Port of Iberia, Louisiana

Final Feasibility Report

Appendix E - Value Engineering Team Study Report

Appendix F – Independent Technical Review Comments and
Resolutions

Option A Eliminate South and East Sides

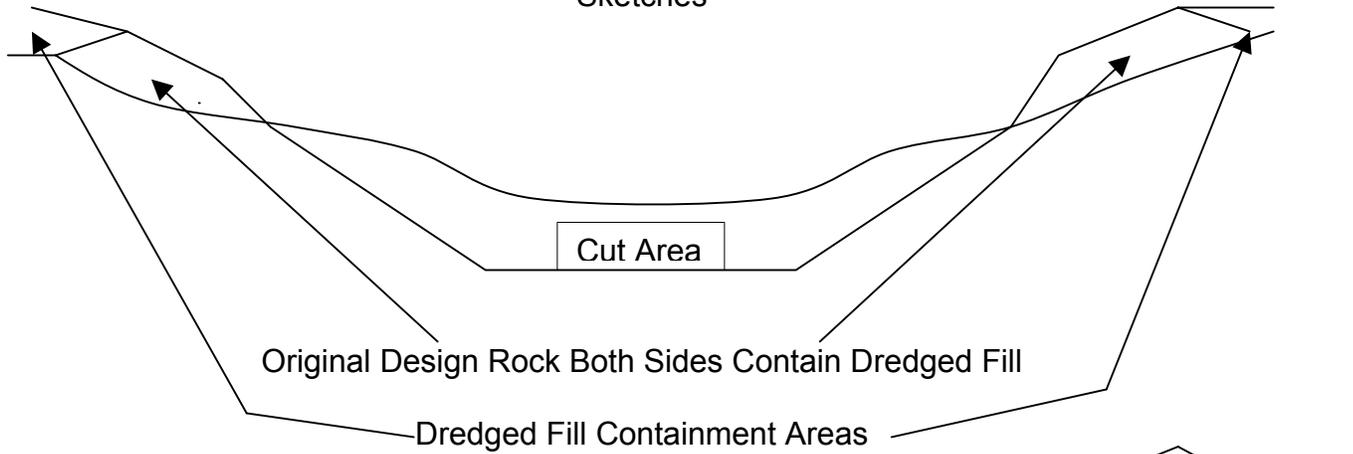
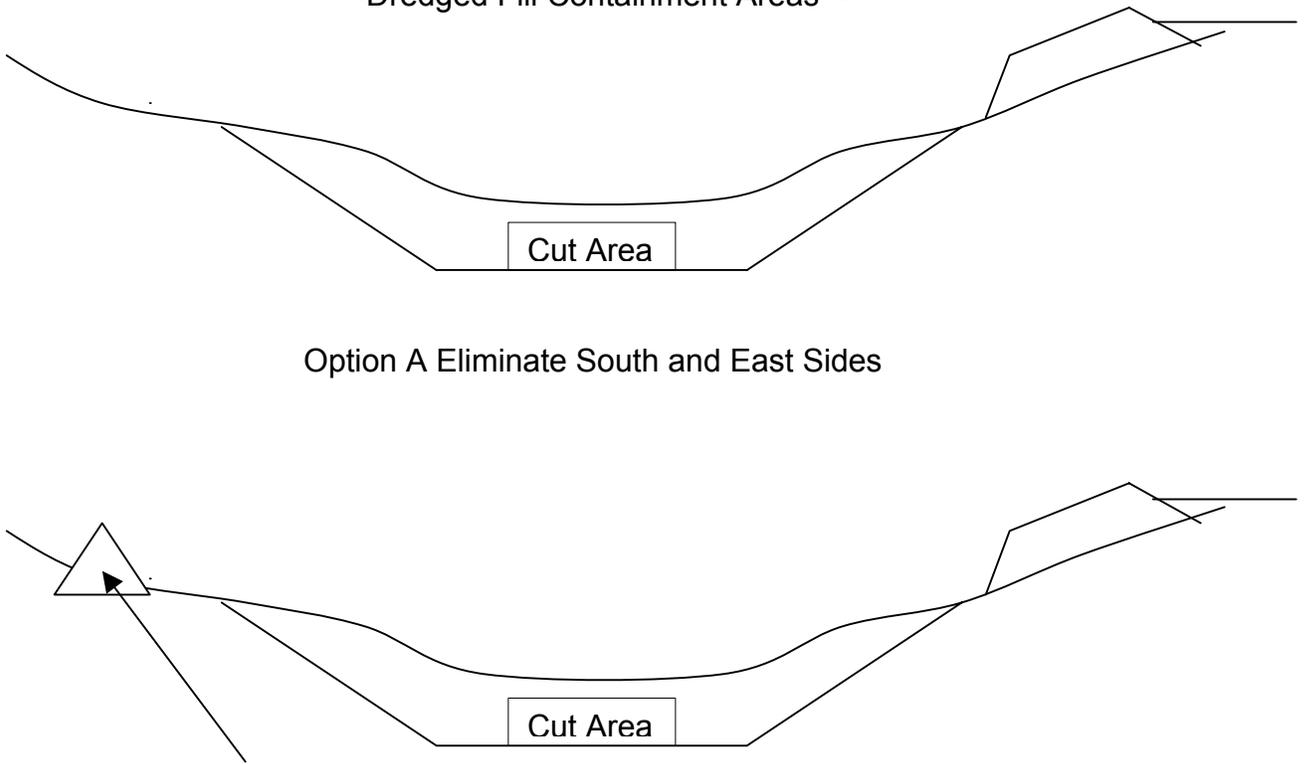
1. Decreased rock quantity.
2. Marsh creation is in a more stable area.
3. Faster construction.
4. The disposal may become the base and borrow for future levees.
5. Reduced cost.

1. Does not create wetlands on the south and east side.
2. Disposal on may encroach on existing marsh area.
3. May not reduce existing bank erosion on the south and east sides. (Option A)

Fig #. Proposal One (1) – Delete North Swing Gate.

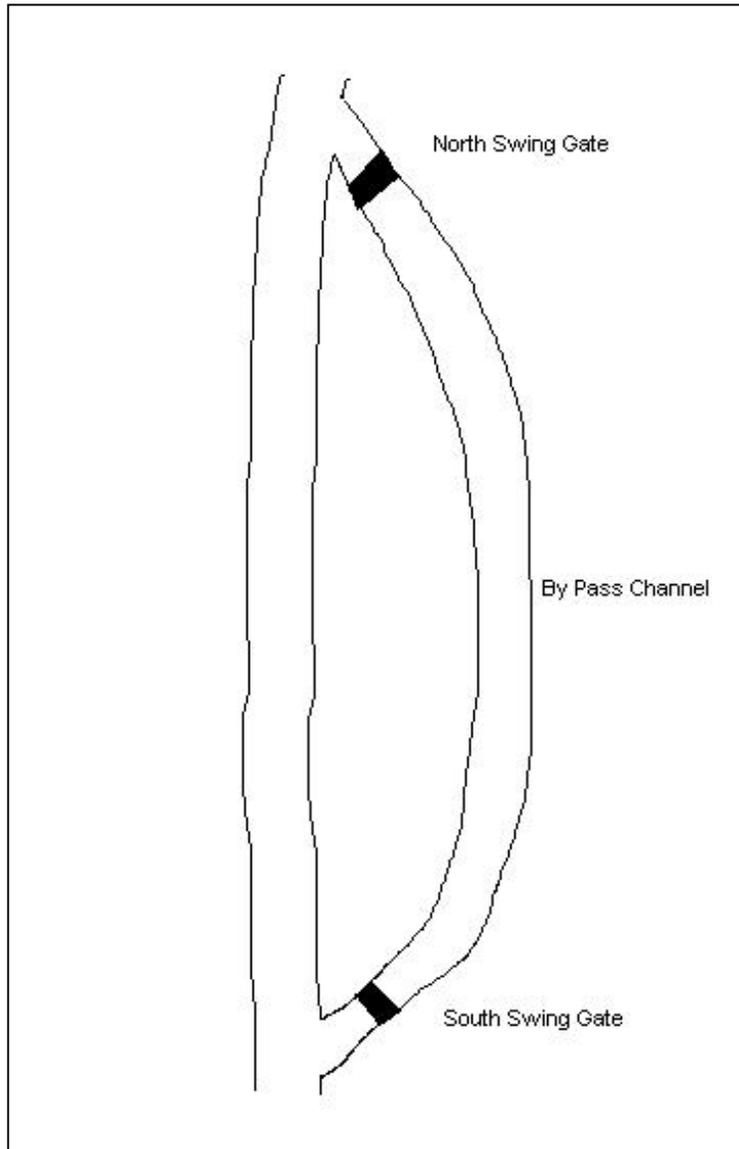
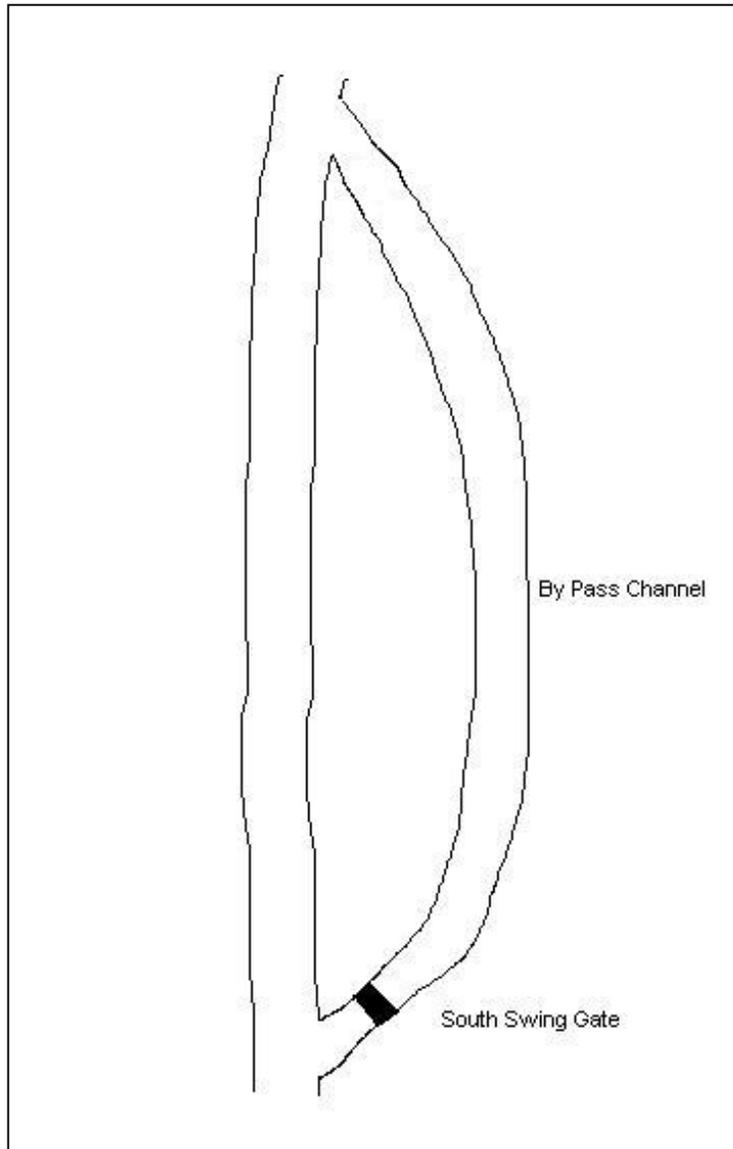
The need for a redundant gate is appears to be marginal form both navigation and environmental functional requirements. Navigation use of the bypass channel will be infrequent. Large rigs can schedule passage at favorable tide conditions, negating the need for "Lockage" that a second gate would provide. Saltwater conveyance by means of continuous leakage or during infrequent openings for large rigs would be almost negligible to the freshwater balance of the basin. This configuration (a single by-pass gate) is being developed for the Houma Navigation Channel and Lock system.

SECTION THRU PROPOSED BRACED SHEET PILE WALL

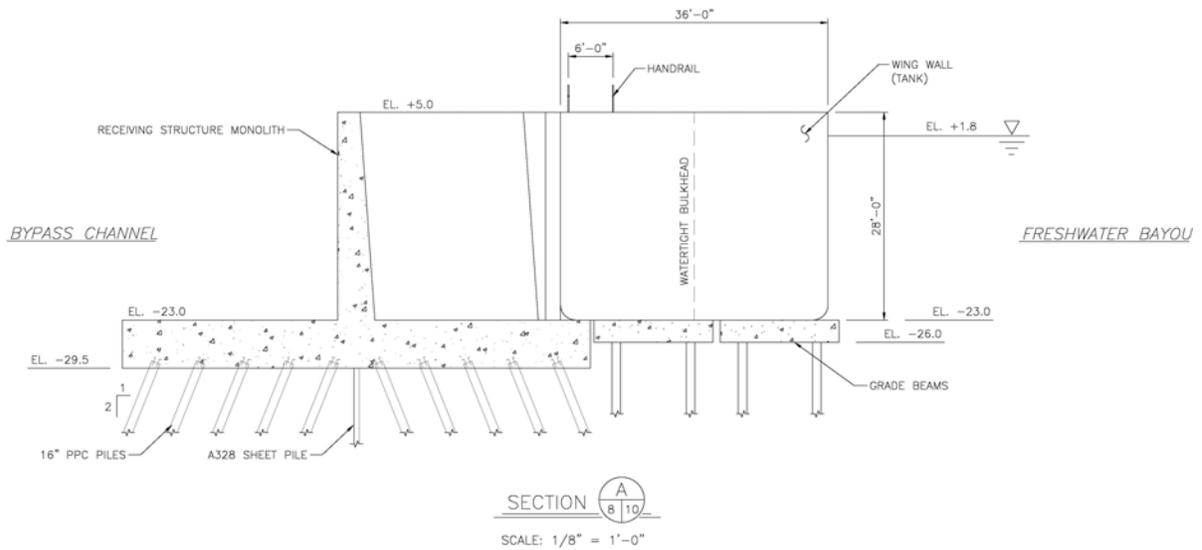
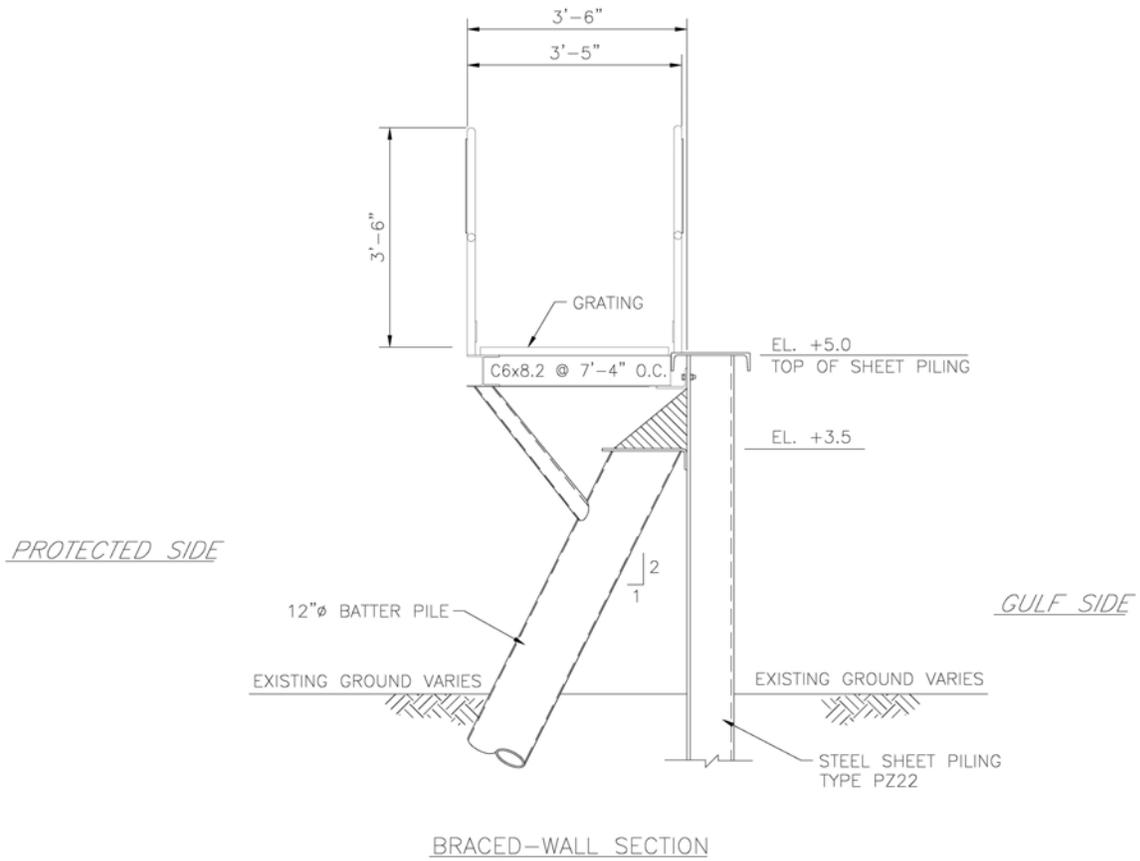
1. Can be constructed without the use of cofferdams(in the wet construction)
2. Reduced construction cost.
3. Construction time will be reduced.
4. Reduced disruption to marine traffic.
5. Particularly practical if two gates are constructed.

1. Requires that contractor be familiar with in the wet construction tolerances on caisson installation difficult to achieve.
2. Will require a good seal between the barge and caisson.
3. Will require additional maintenance costs due to effects of salt water on steel sheet pile.
4. Cathodic protection will be required.
5. Design life will be shorter (Approx. 25 years.)
